APPEAL RECOMMENDATION REPORT

City Planning Commission

Case No.: ZA-2018-7378-ZV-TDR-SPR-1A

PROJECT LOCATION: 1123-1161 South Main Street; 111 West 12th Street

① Plot Plan-12TH ST EASEMENT
3/32" = 1'-0"

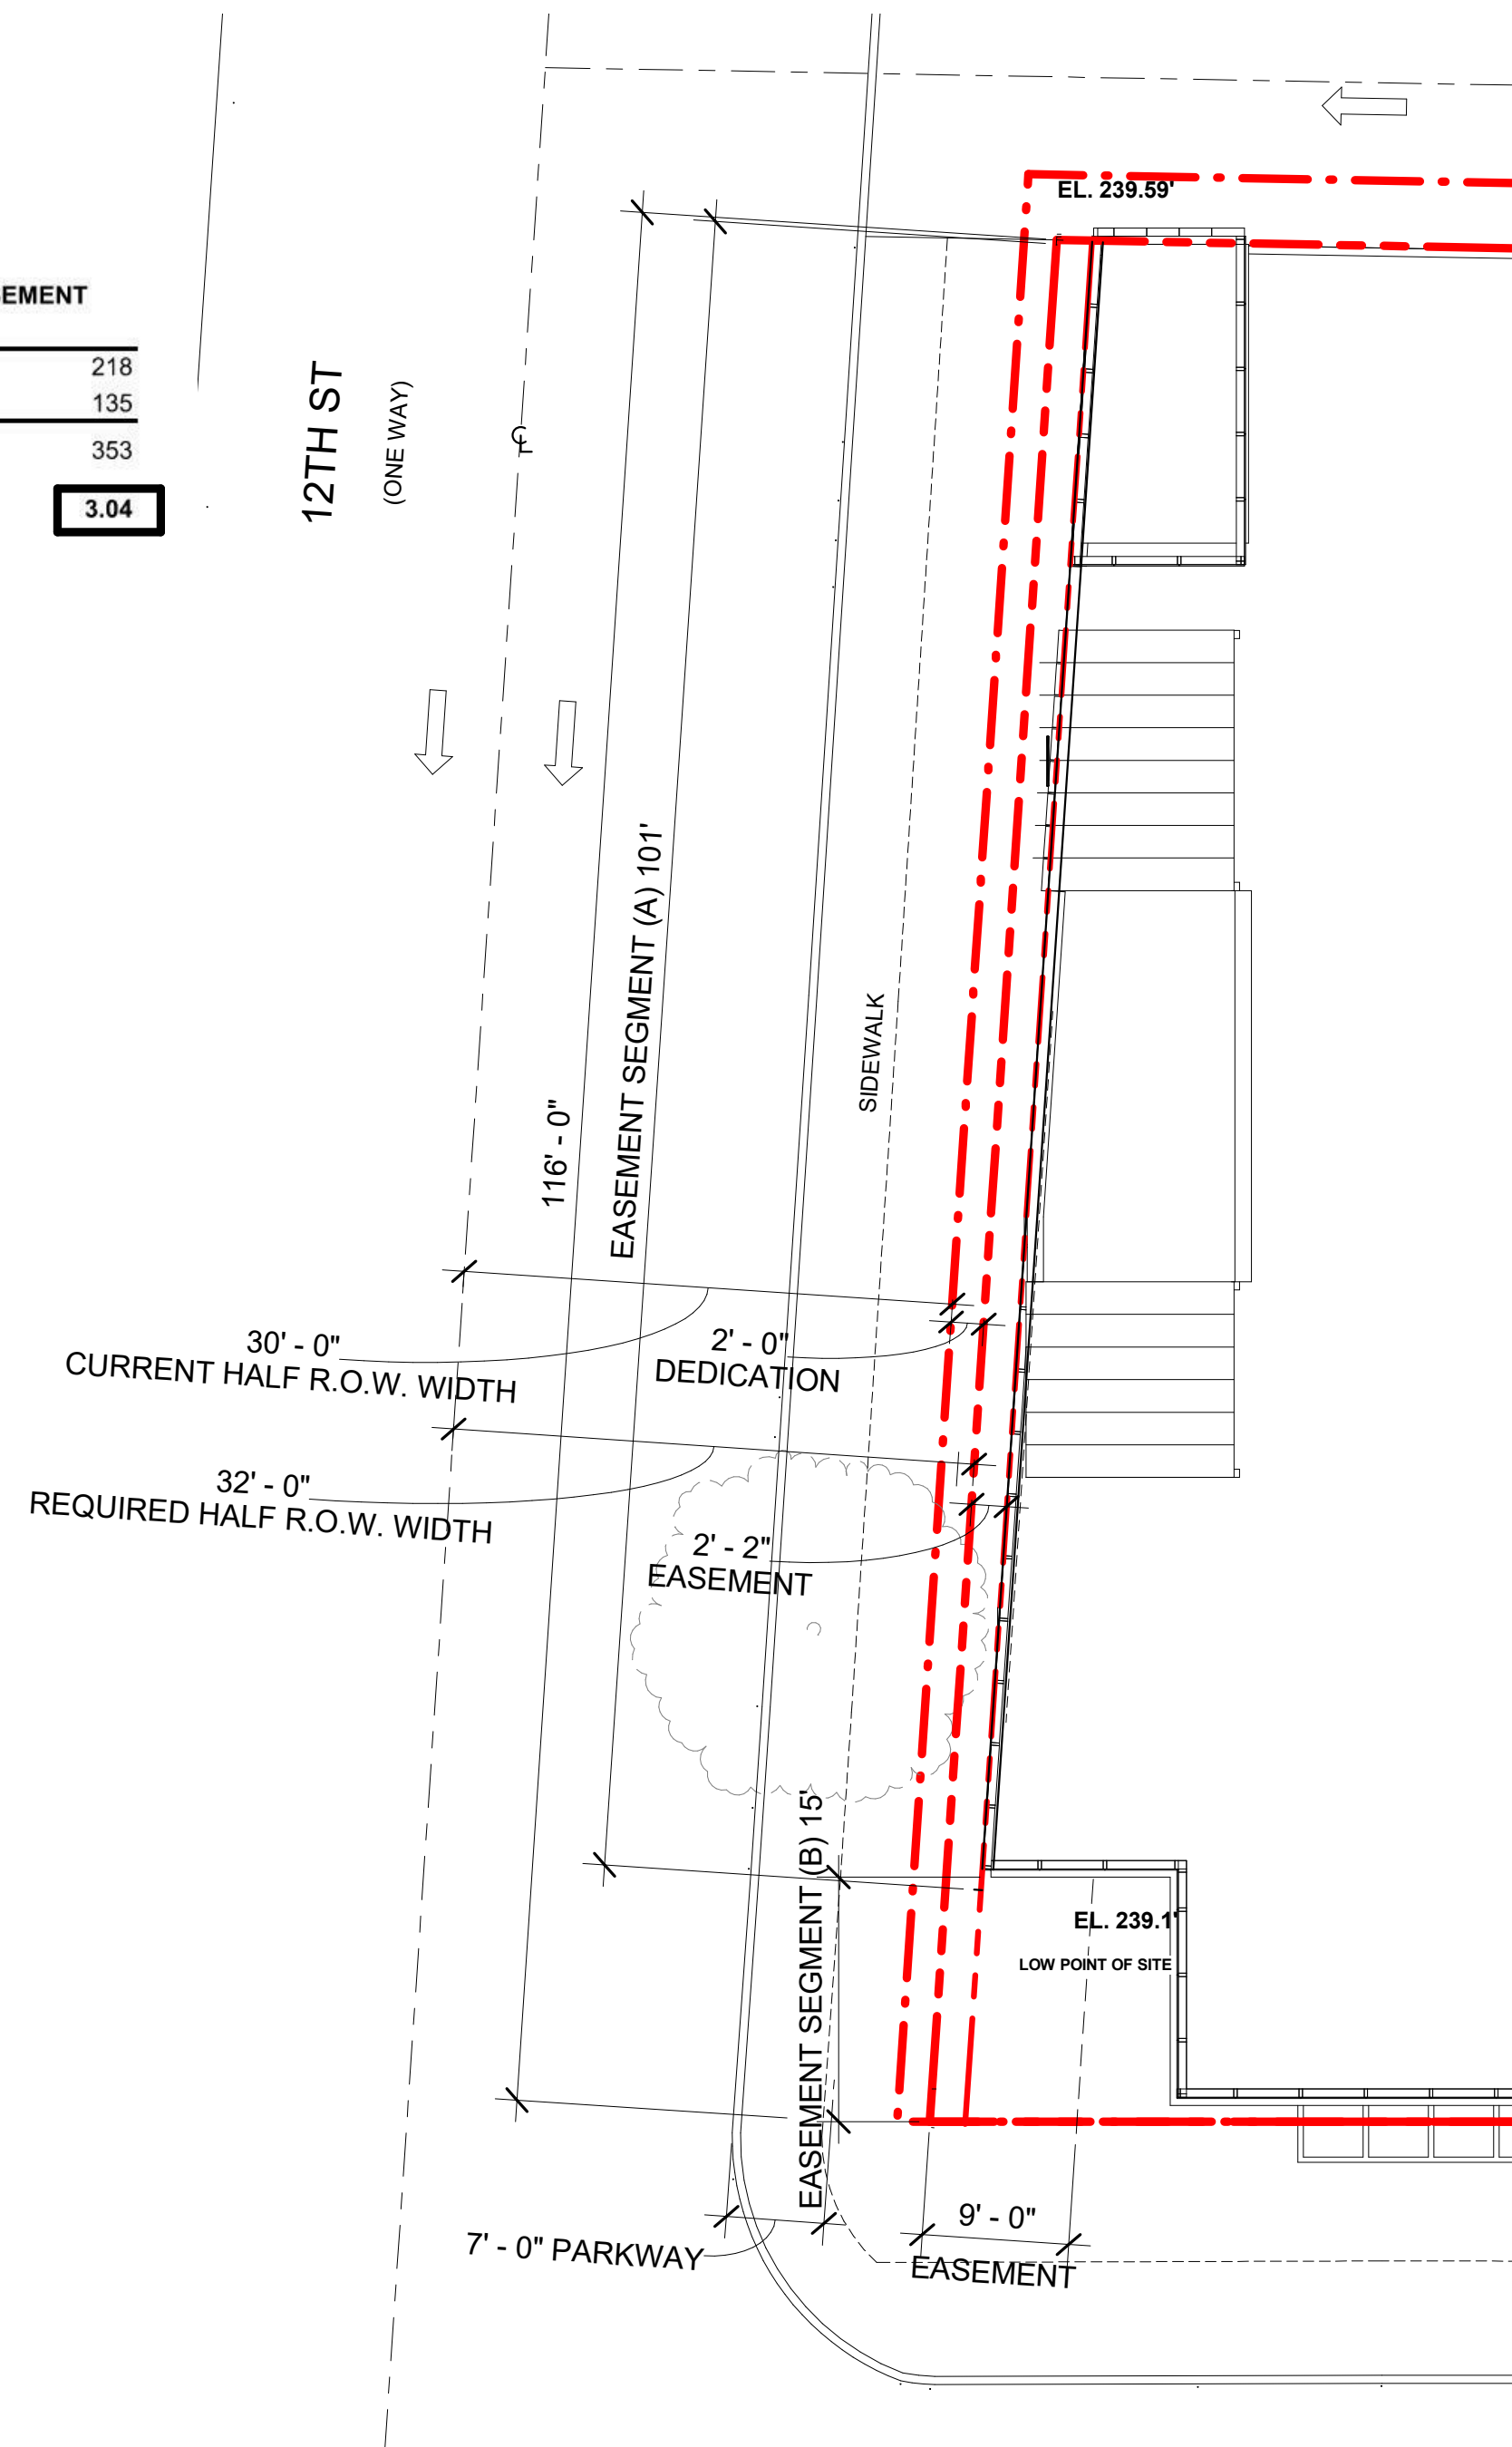
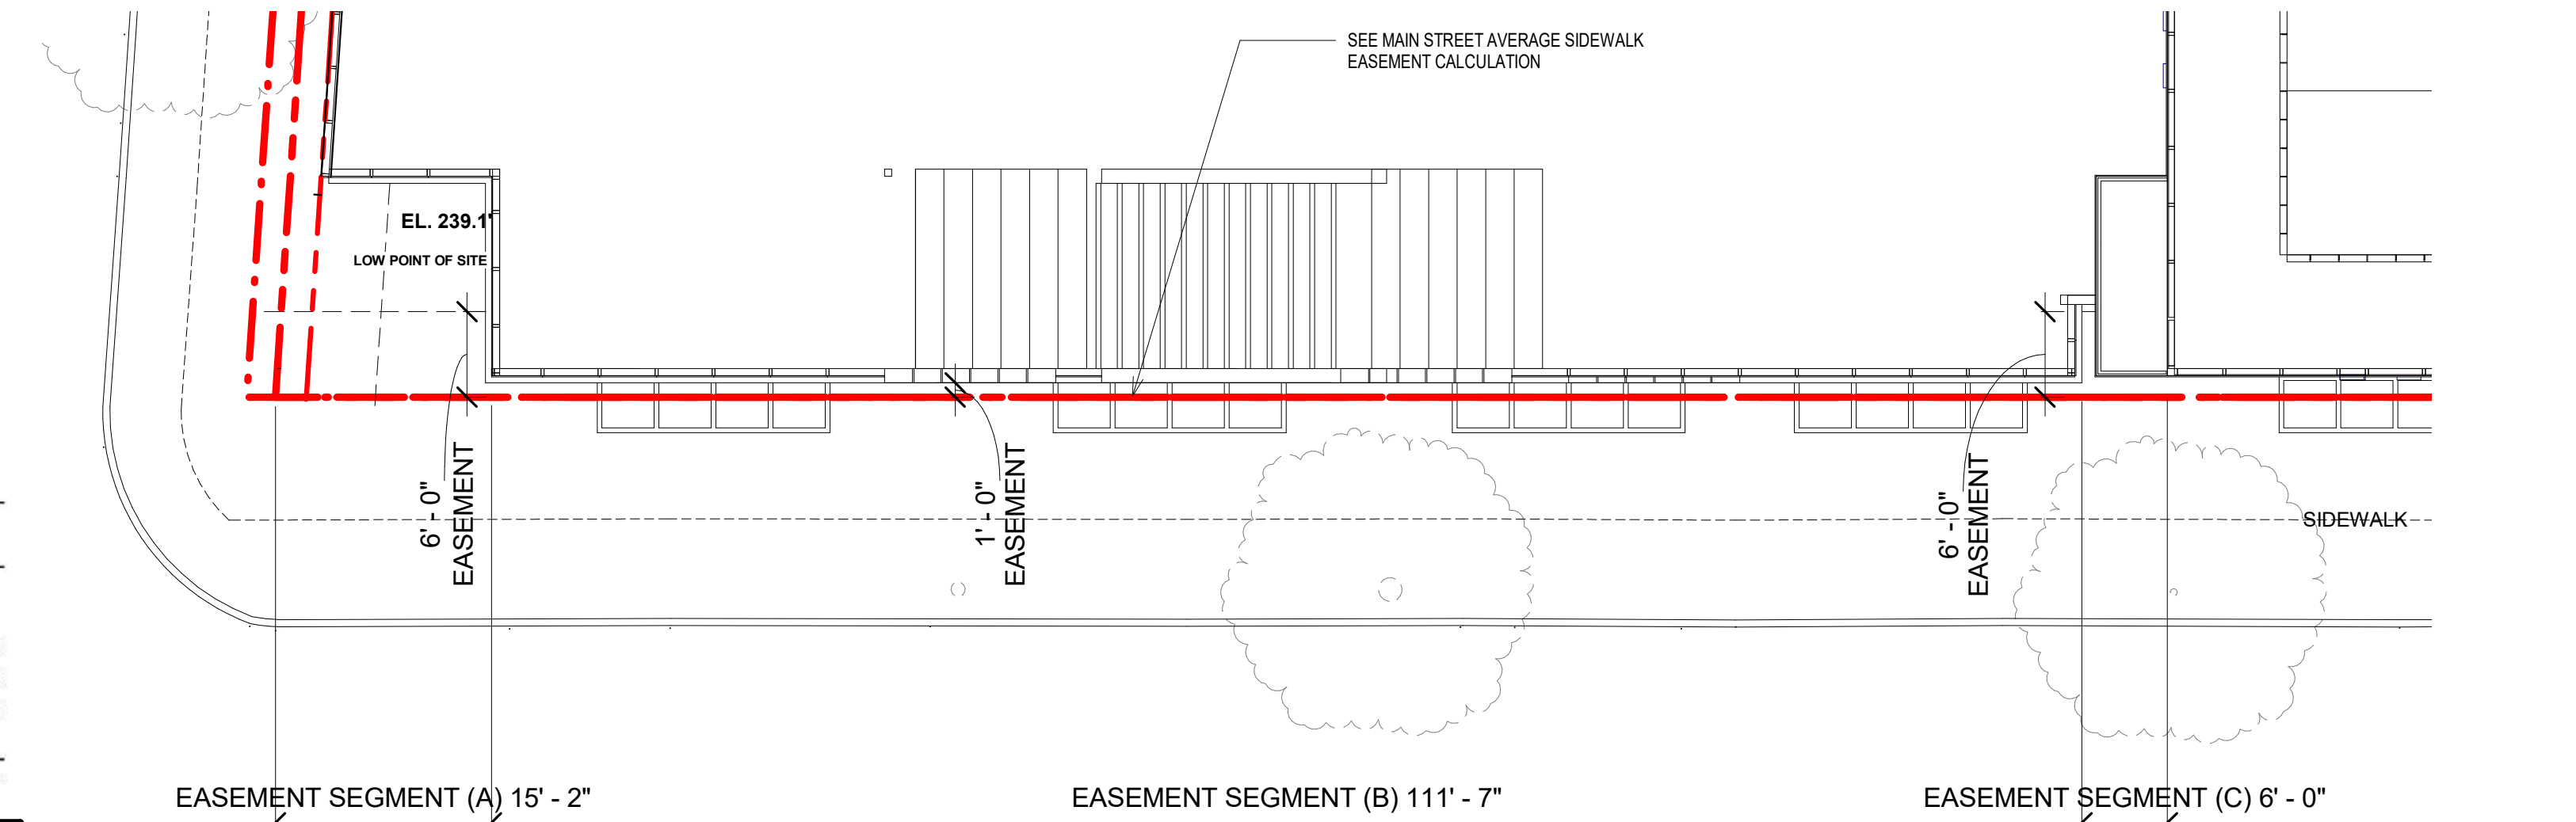
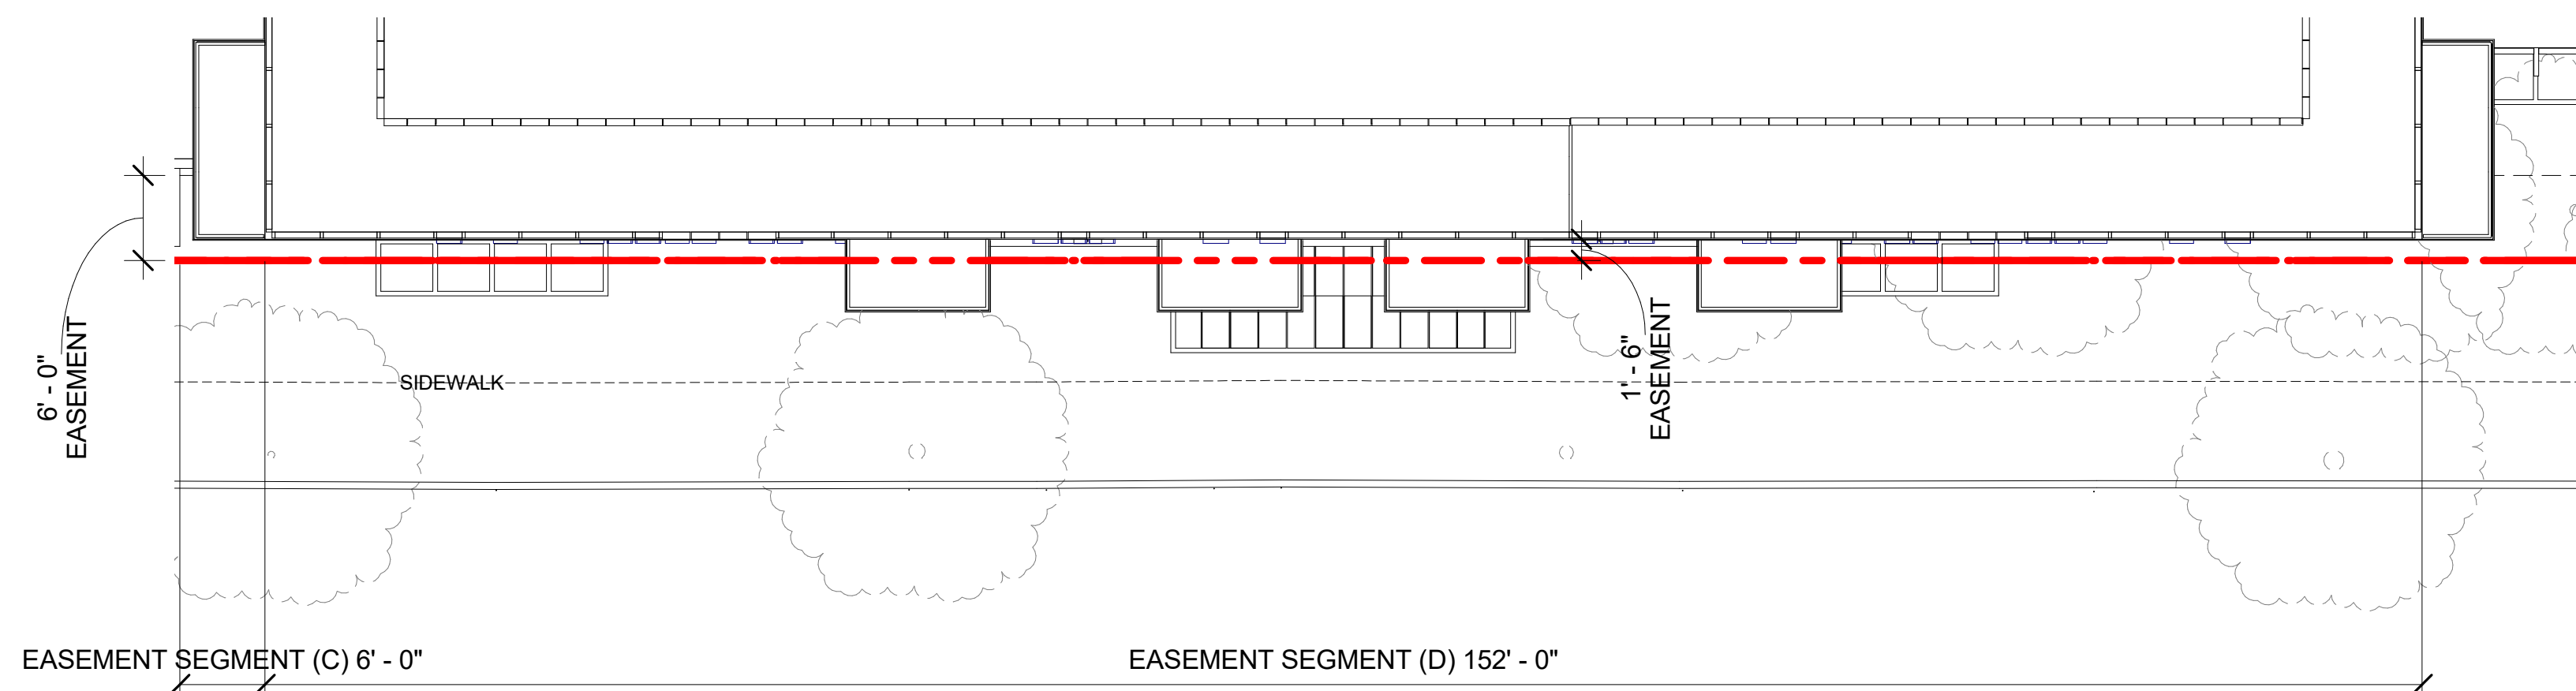
- a. **Sidewalk Easement.** The project shall provide an average sidewalk easement of three feet along 12th Street and two feet along Main Street, as shown on Sheet A0.01.1 of Exhibit "A." The building shall not project more than five horizontal feet over the required sidewalk easement nor below 40 vertical feet above the sidewalk.

- a. **Sidewalk Easement.** The project shall provide an average sidewalk easement of three feet along 12th Street and two feet along Main Street, as shown on Sheet A0.01.1 of Exhibit "A;" **stamp-dated August 18, 2022.** The building shall not project more than five horizontal feet over the required sidewalk easement nor below 40 vertical feet above the sidewalk.

shown on Sheet A0.01.1 of Exhibit “A” **stamp-dated August 18, 2022,** the project proposes an average sidewalk easement of 2.20 feet along Main Street and 3.04 feet along 12th Street and therefore complies with the sidewalk easement requirements.
